A27 EAST OF LEWES

DETAILED MODIFICATION MOD-2

THE HIGHWAYS ENGLAND (A27 TRUNK ROAD EAST OF LEWES IMPROVEMENT SCHEME) (SHARED USE PATH) (SIDE ROADS) ORDER 2019

DETAILED MODIFICATION No.2

Site Plan 2:

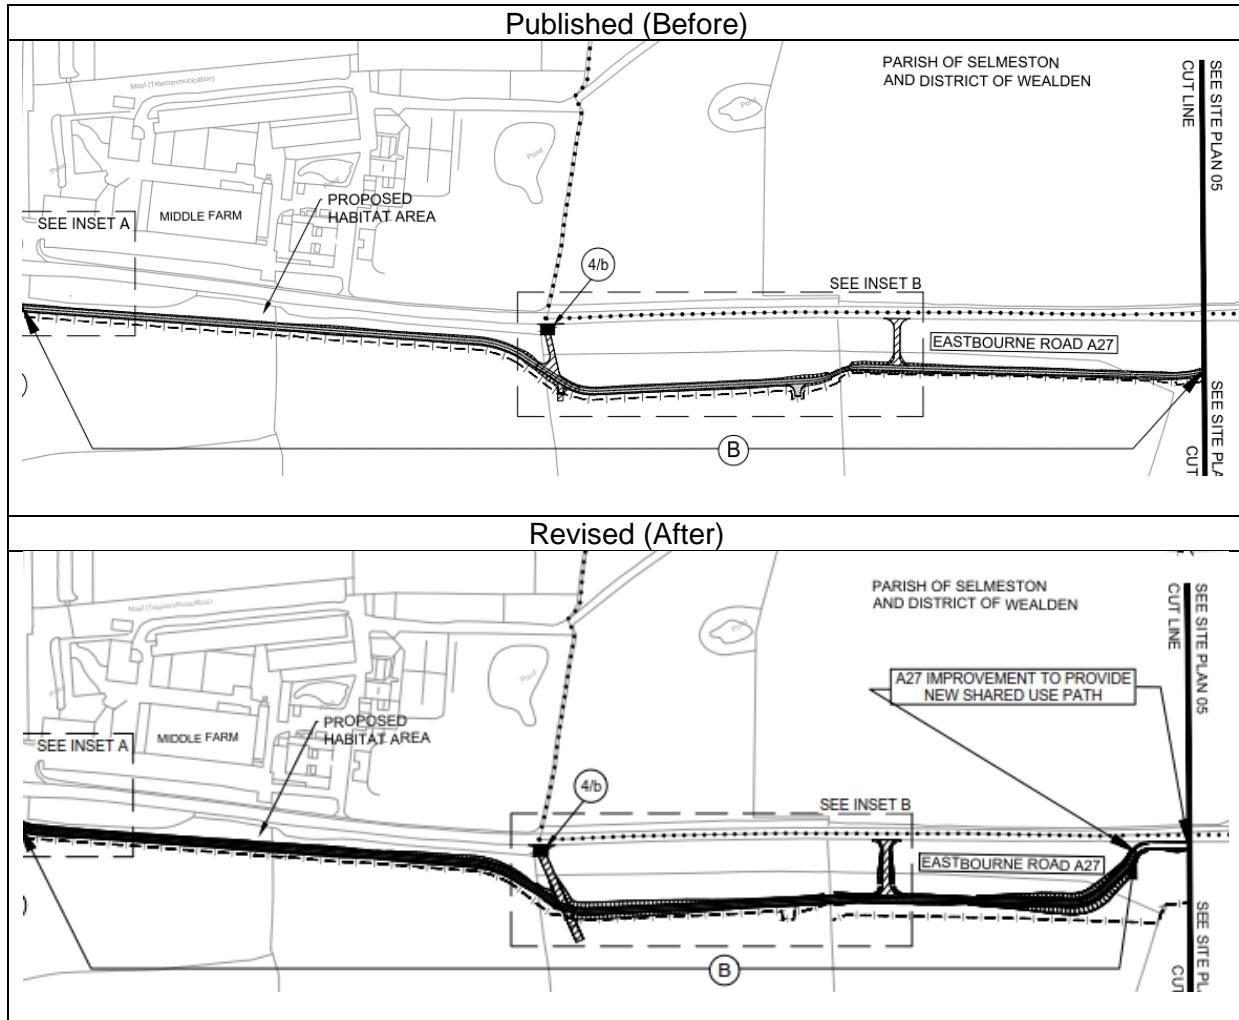
9. Amendment of new shared use path alignment near the north east corner of the Wick Street to reflect the revised design.

Site Plan 4:

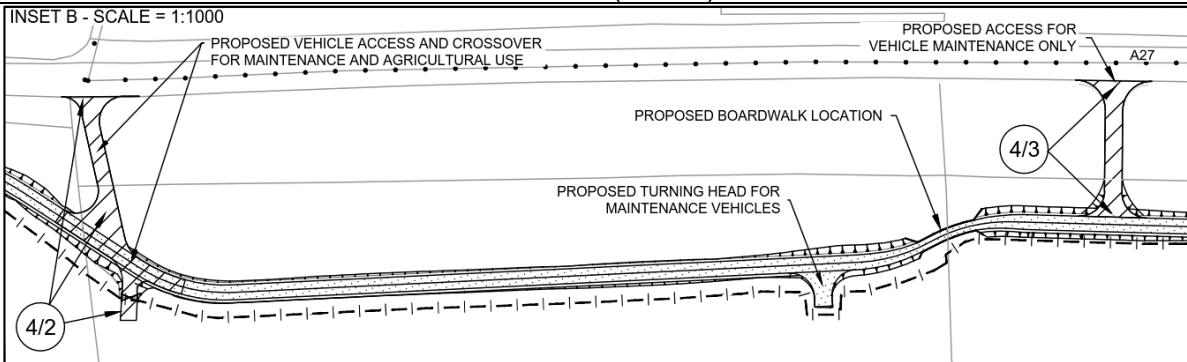
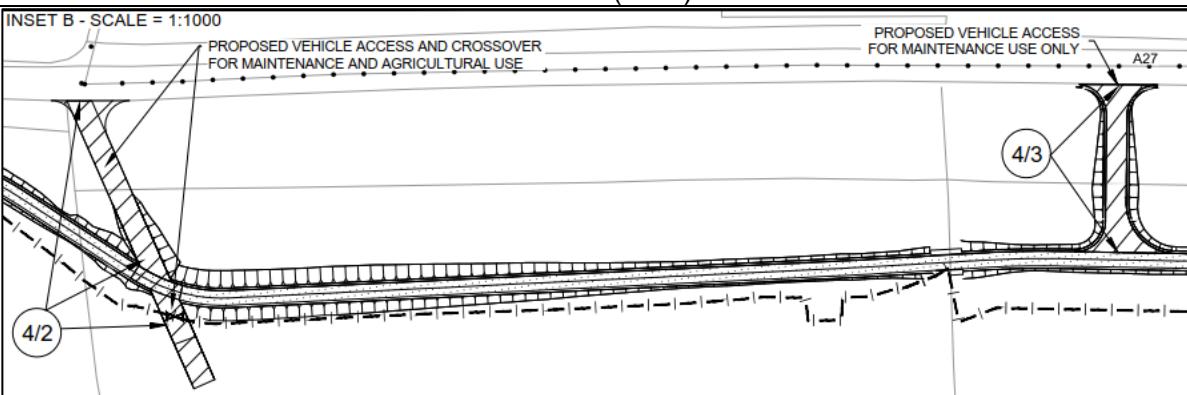
10. Amendment of "New Highway to be provided" reference "B" (including hatch and leader) to reflect revised design (reduced extent of reference B).
11. Amendment of "Private means of access to be stopped up for which a substitute is to be provided and new private means of access which are otherwise to be provided" reference 4/2 to reflect revised design.
12. Amendment of "Private means of access to be stopped up for which a substitute is to be provided and new private means of access which are otherwise to be provided" reference 4/3 to reflect revised design.
13. Removal of proposed turning heads for maintenance vehicles.
14. Removal of proposed boardwalk location.
15. Error amendments to the new trunk road boundary to be consistent with the published Compulsory Purchase Order boundary

Site Plan 5:

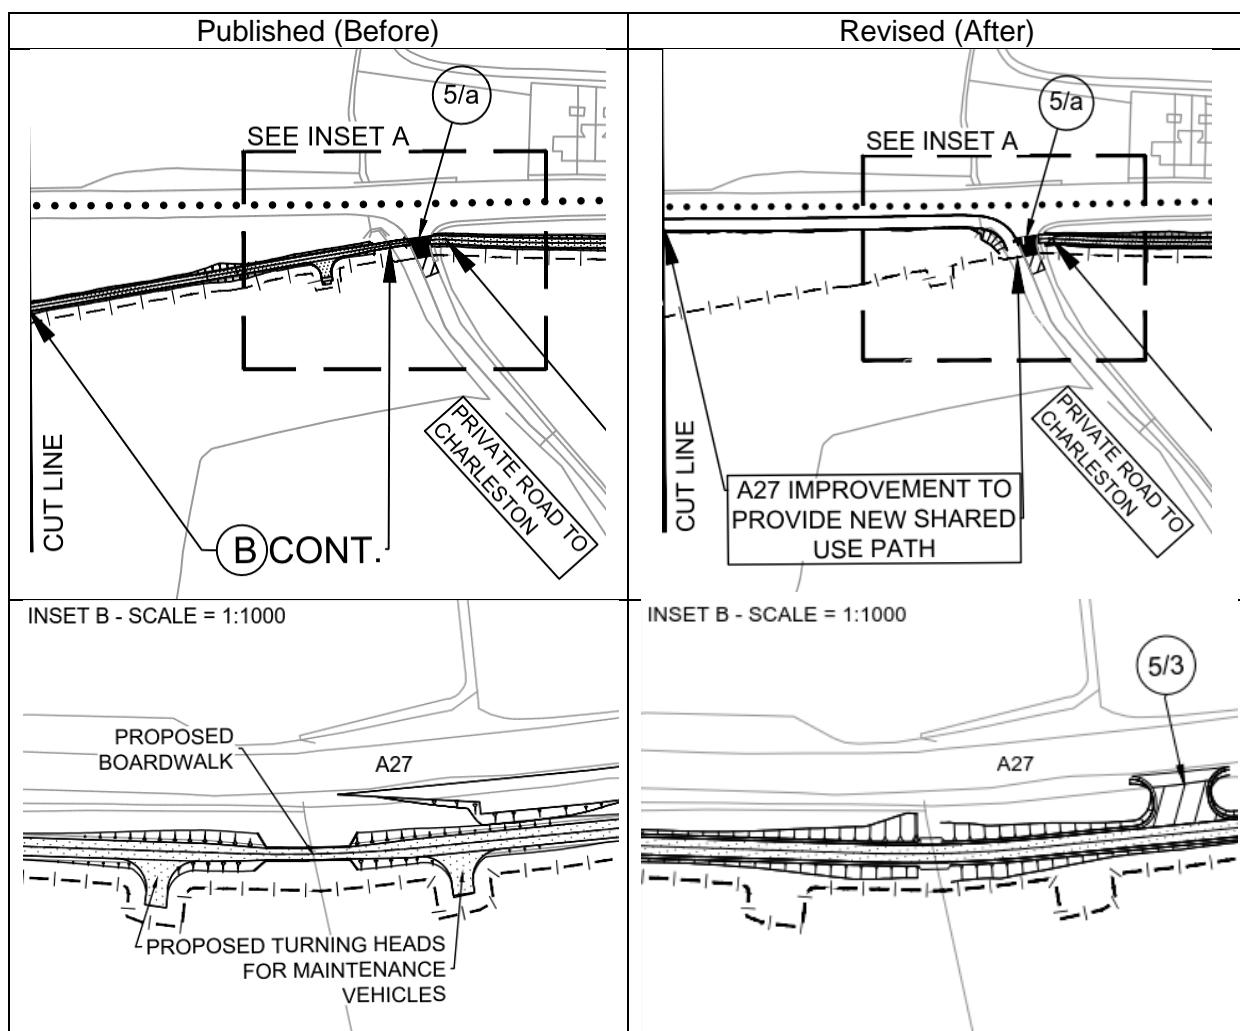
16. Removal of part of "New Highways to be provided" reference "B" (including hatch and leader). Replacement with "A27 improvement to provide new shared use path" to reflect revised design.
17. Removal of proposed turning heads for maintenance vehicles.
18. Removal of proposed boardwalk location.
19. Conversion of maintenance layby to a PMA for maintenance use referenced 5/3

Site Plan 6:

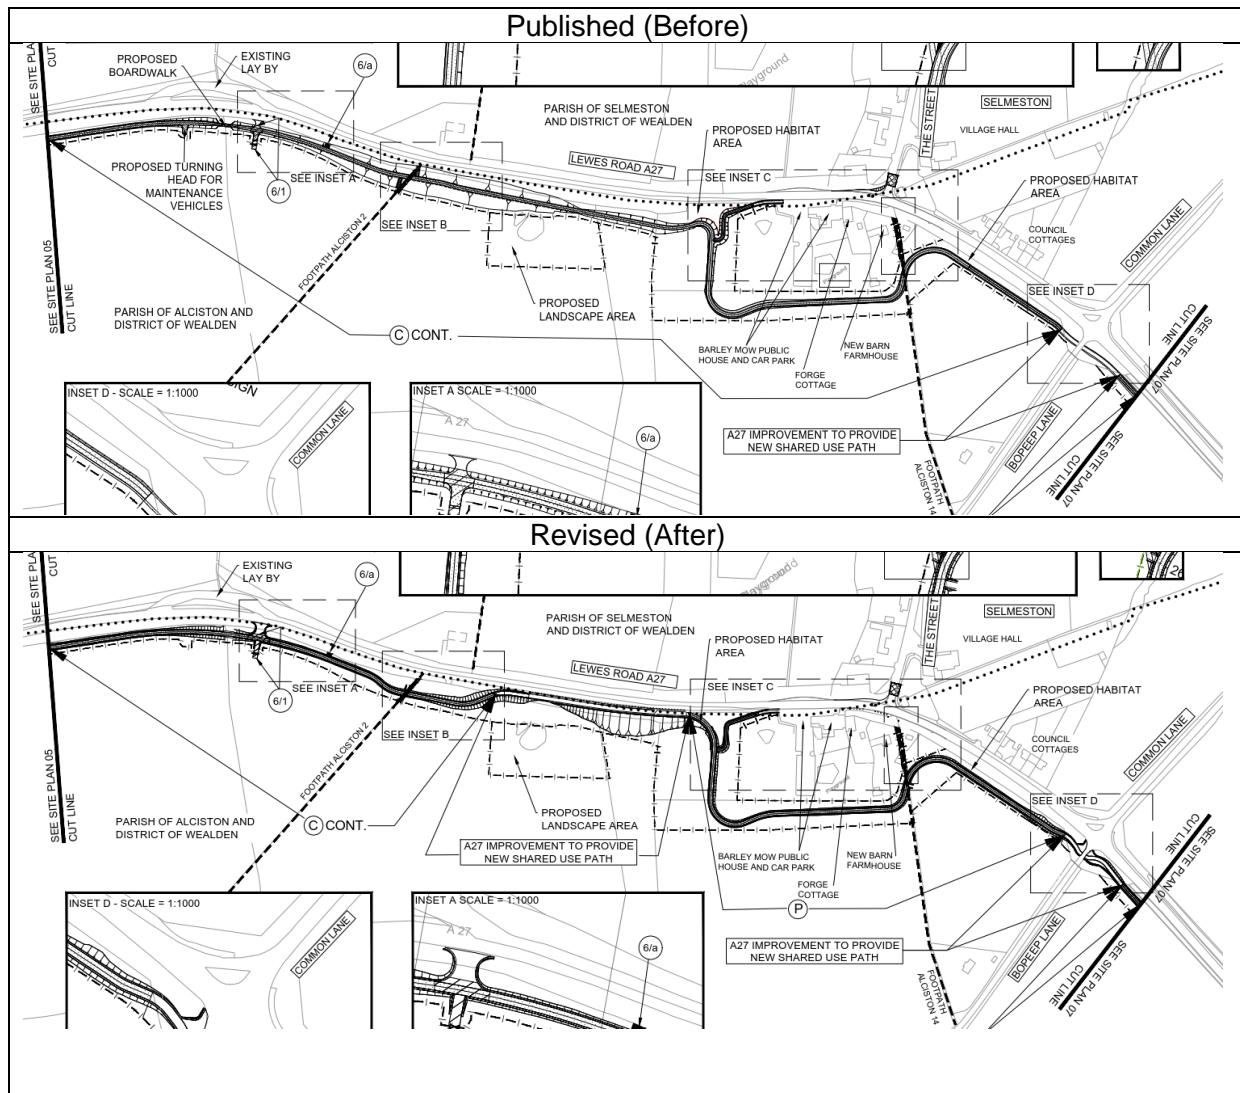
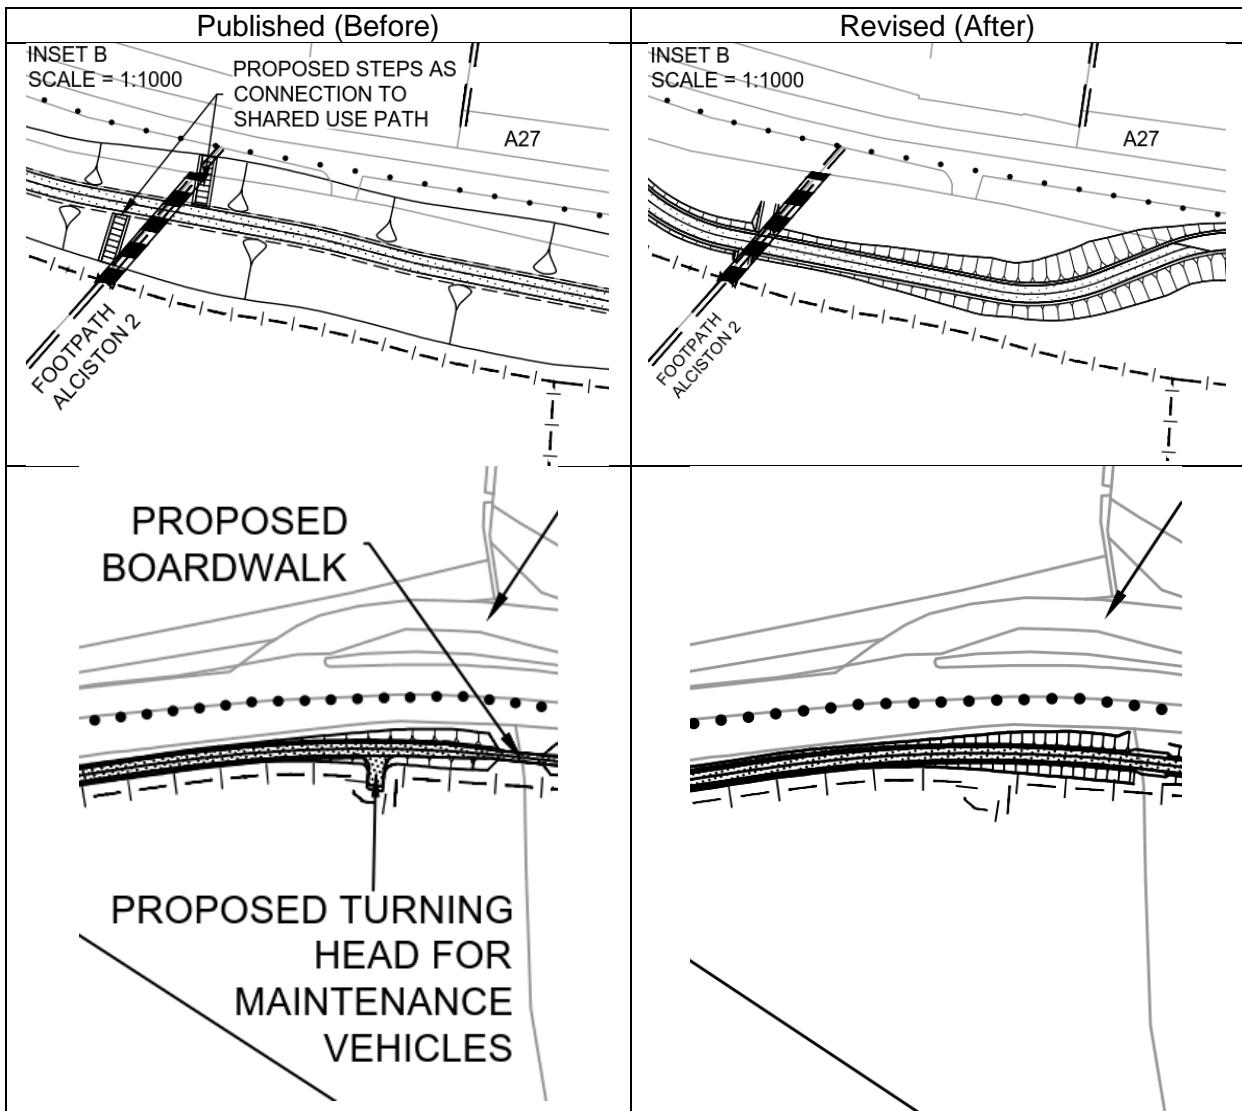
20. Amendment of "New Highway to be provided" reference "C" (including hatch and leader) to reflect revised design (reduced extent of reference C). Section of route reference C replaced with "A27 improvement to provide new shared use path" to reflect revised design.
21. Addition of "New Highways to be provided" referenced P to reflect revised design.
22. Removal of proposed steps as connection to shared use path. Inset B
23. Removal of proposed turning head for maintenance vehicles.
24. Removal of proposed boardwalk location.

Site Plan 7:

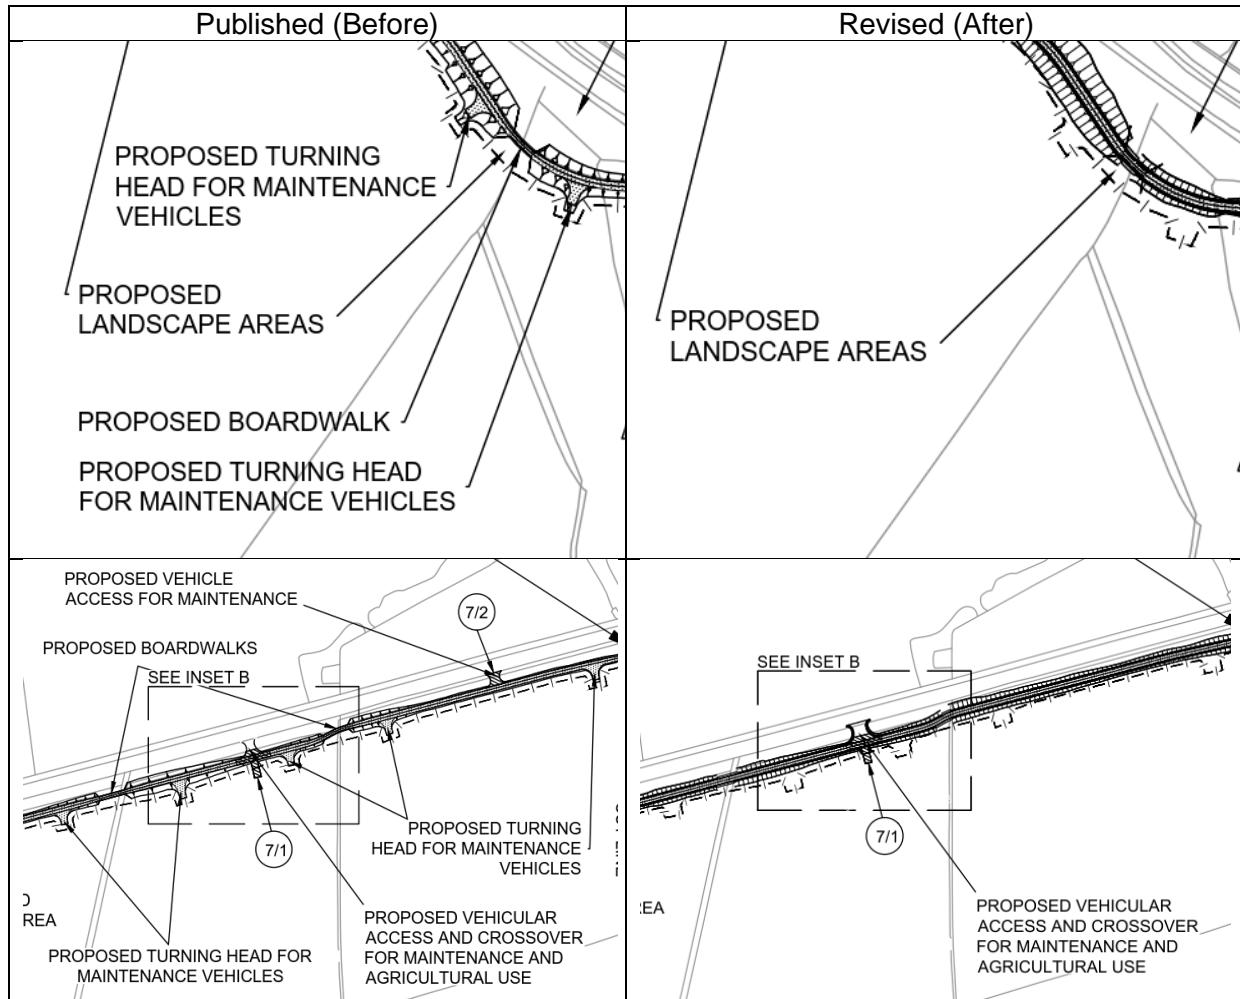
25. Removal of seven proposed turning heads for maintenance vehicles.
26. Removal of two proposed boardwalks.
27. Removal of PMA (for maintenance use) reference 7/2.

Site Plan 8:

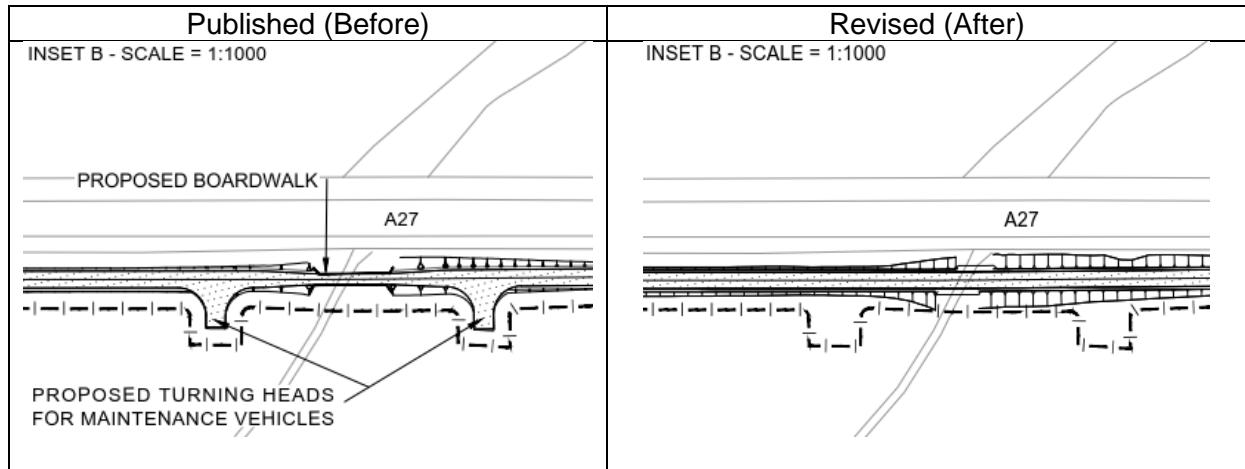
28. Removal of two proposed turning heads for maintenance vehicles.
29. Removal of proposed boardwalk.
